**Planning Commission Meeting Agenda**

Tuesday, November 19, 2024, 5:30 PM

- Subject:** Copper Baron Condo Unit 2 Conversion to Employee Housing  
(Class B Minor Combined Hearing; PL-2024-0427)
- Date:** November 11, 2024 (for the November 19, 2024 meeting)

- Project Manager:** Ellie Muncy - Planner I
- Applicant/Owner:** Craig Campbell
- Proposal:** The applicant proposes to convert the 1039 sq. ft. commercial office unit to a 2-bedroom, 2-bath residential employee housing unit, and install new windows in Unit 1 and Unit 2. This application is subject to a Development Agreement approved by the Town Council on September 10, 2024.

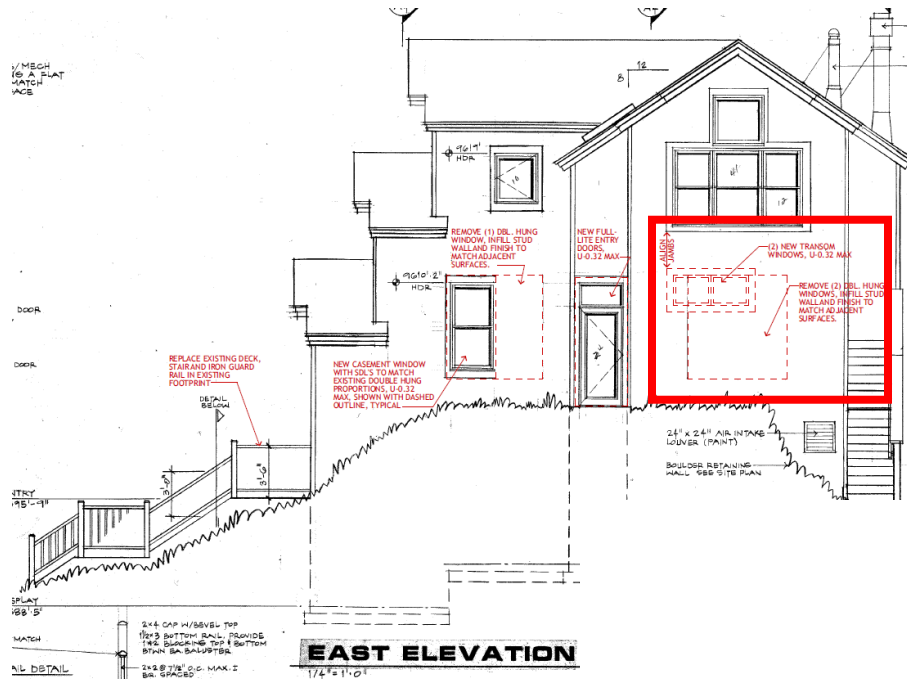
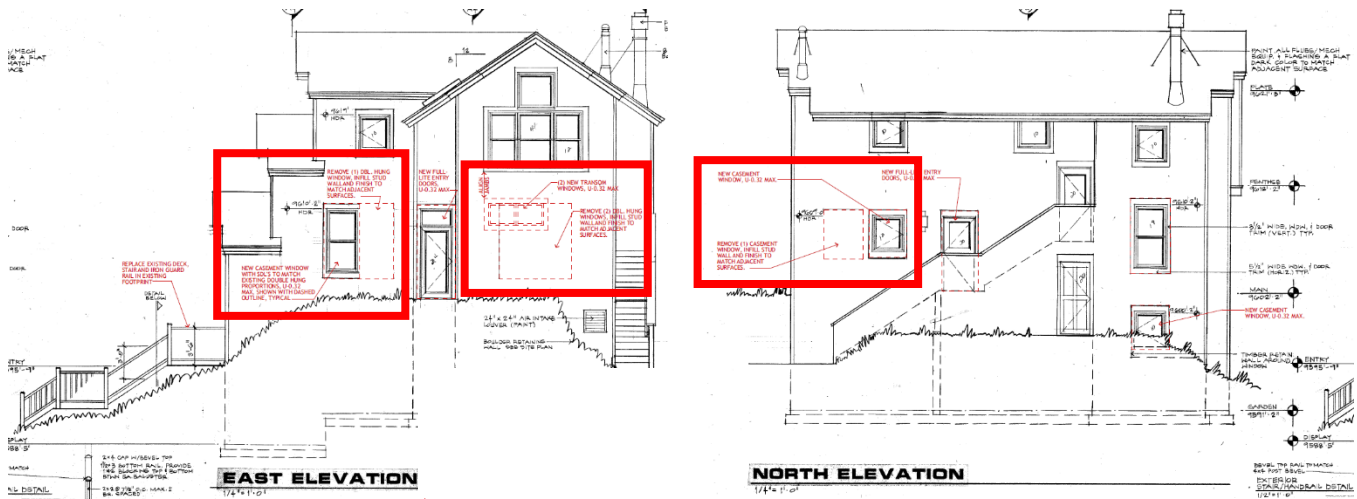
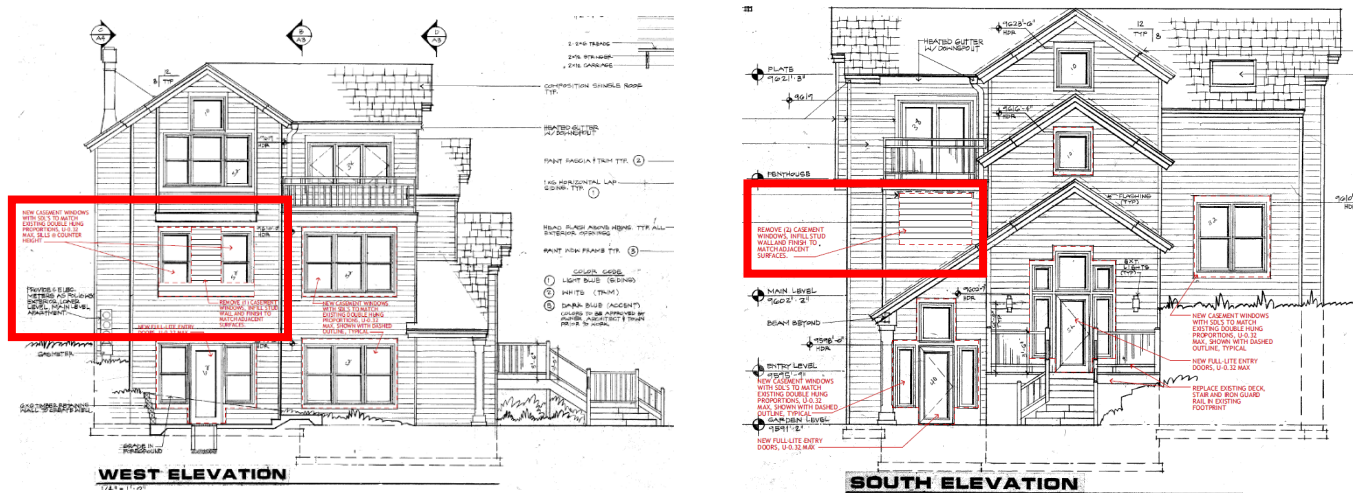
Proposed changes to each elevation of the primary structure include the following:

#### East elevation (side):

- Remove three double hung windows
- Add two transom windows

#### West elevation (side):

- Remove one double hung window
- Reduce the height of two windows

North elevation (rear):

- Remove one casement window

- Remove two casement windows

Design Standard 91 states, “use building components that are similar in size and shape to those found historically along the street” which includes windows and doors.

With each window removed, the opening will be infilled with siding to match the existing siding style and color. All remaining double hung windows on the building for Unit 1 and Unit 2 will be replaced with casement windows with simulated divided lites (SDL) to match the existing double hung windows. Staff finds the proposed windows will sufficiently mimic double hung windows for a non-historic building where many casement windows already exist.

Design Standard 168 states, “windows should be similar in size and shape to those used historically,” and Priority Design Standard 95 states, “the proportion of window and door openings should be similar to historic buildings in the area.”

Staff finds most of the windows existing in the building match the double hung size and shape used historically. Each existing double hung window is proposed to be replaced with a casement window of the same size and shape. Staff has no concerns with this replacement.

Staff finds the addition of the two transom windows on the east elevation to also comply with Design Standard 168 as transom windows were used historically and can be seen on the nearby historic buildings of 203 and 205 South Ridge Street. Additionally, though the addition of the transom windows comes with the removal of a set of double hung windows on the east elevation, Staff is not concerned as the eastern elevation faces another non-historic building and is not easily visible. Staff has no concerns with this addition.

Priority Design Standard 96 states, “use a solid to void ratio that is similar to those found on historic and supporting buildings.”

The applicant proposes the removal of a set of double hung windows, a single double hung from a set of two, one smaller casement window, a single double hung window in the middle of a set of three, and a set of two smaller casement windows. Staff finds these removals, in combination with the addition of two transom windows, to comply with Priority Design Standard 96 as the overall void space in the building will be reduced to better match historic residences in the area. Staff has no concerns with the removals.
